0093003/SFHWHY00414

JNU WAYDELICH CREEK: UPPER & LOWER WALL REPAIRS

GRADING, DRAINAGE, PAVING, STRIPING, AND RETAINING WALL STABILIZATION

As-Built Plans

STATE OF ALASKA
DEPARTMENT OF TRANSPORTATION
AND PUBLIC FACILITIES
JNU WAYDELICH CREEK:
UPPER & LOWER WALL REPAIRS
LOWER WALL PLAN

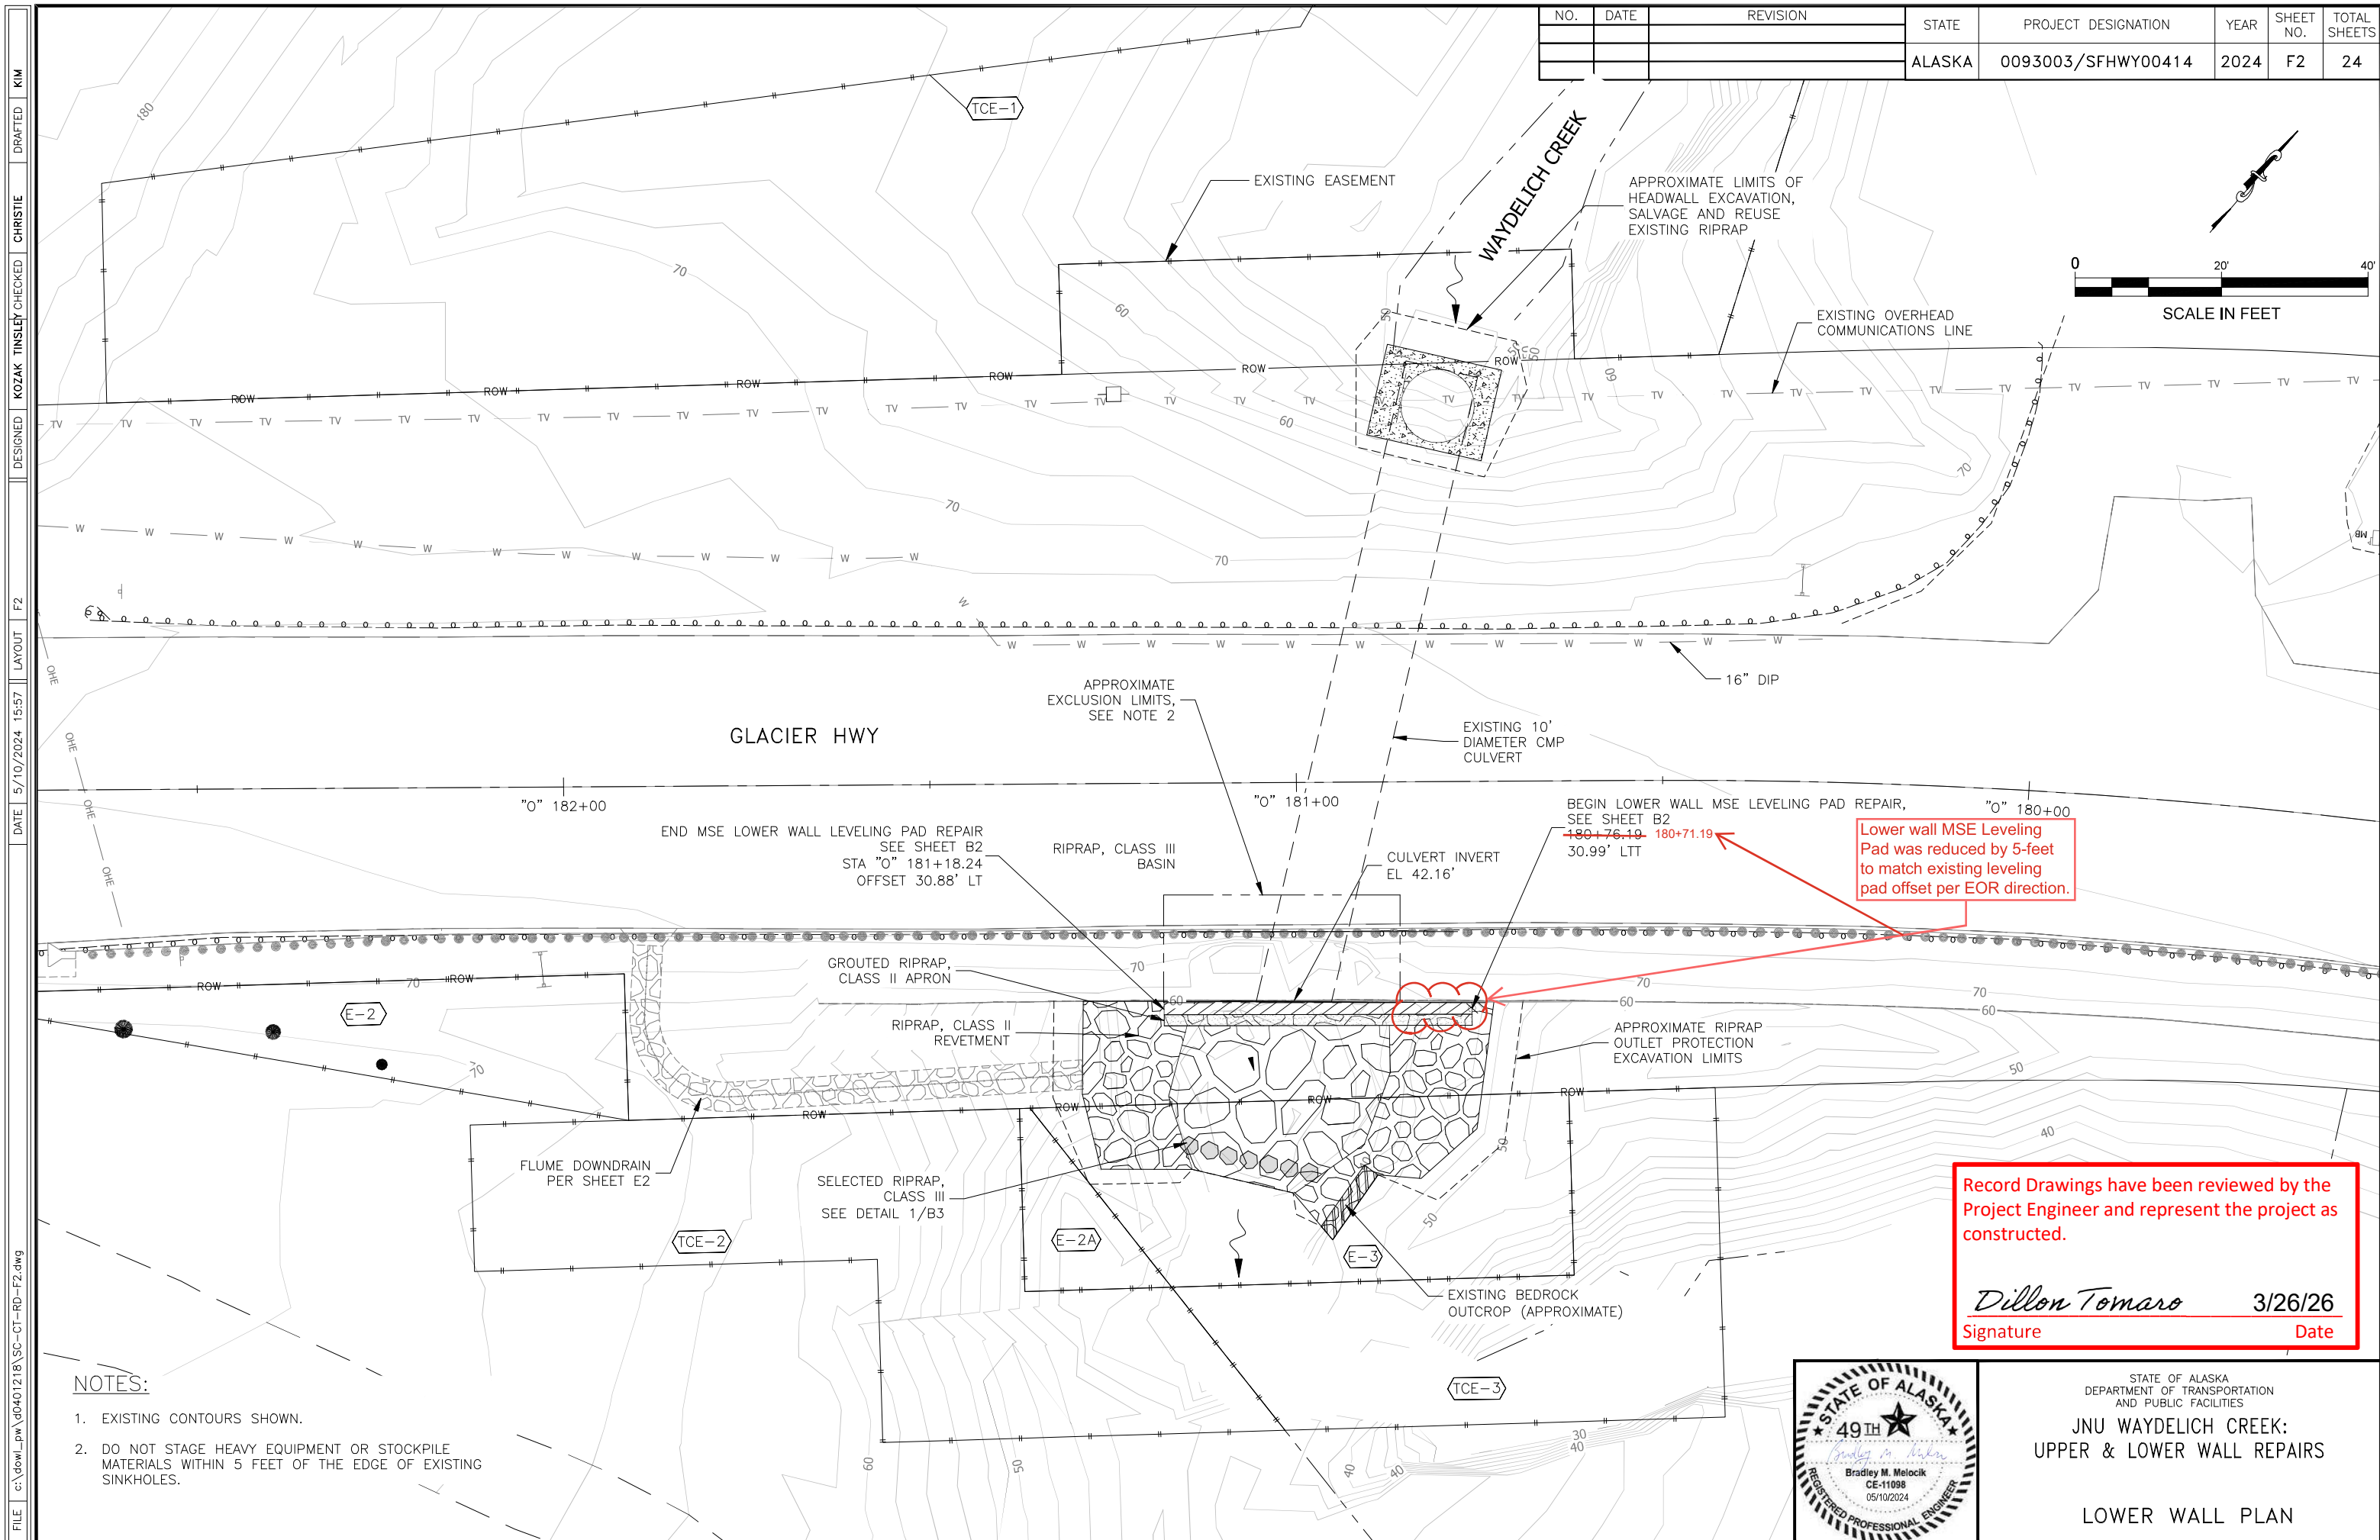
Lower wall MSE Leveling Pad was reduced by 5-feet to match existing leveling pad offset per EOR direction.
